Product Change Notice (PCN)

PCN Number: **PCN-0454705R-02**

Product(s) Affected: **UJ2-BV-1-TH**

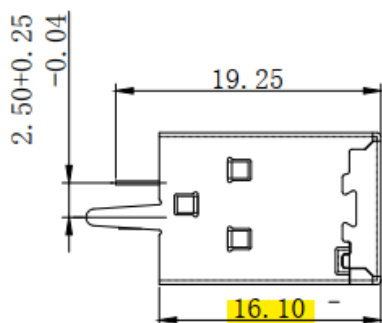
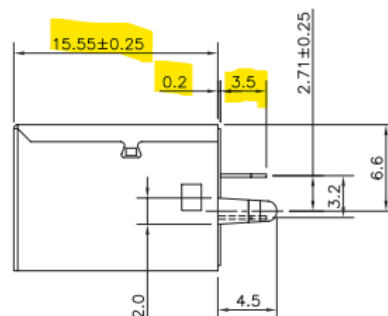
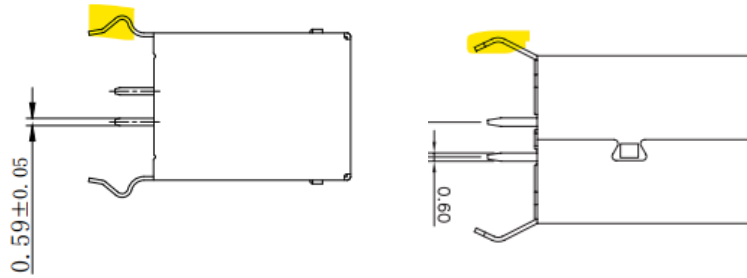
Description of Change: **New Factory Location. Product optimized for improved production yield and board fit. Minor housing difference. Insulator plastic color changed from black to white. Longer legs, taller body, and shorter pin lengths. The leg shape has more exaggerated crimp for a more secure board fit. PCB footprint is equivalent in function and layout. Operating temp range improved. Current capacity increased from 1 amp to 1.5 amp. Insertion force decreased from 35N to 30N. Additional changes in measurements listed.**
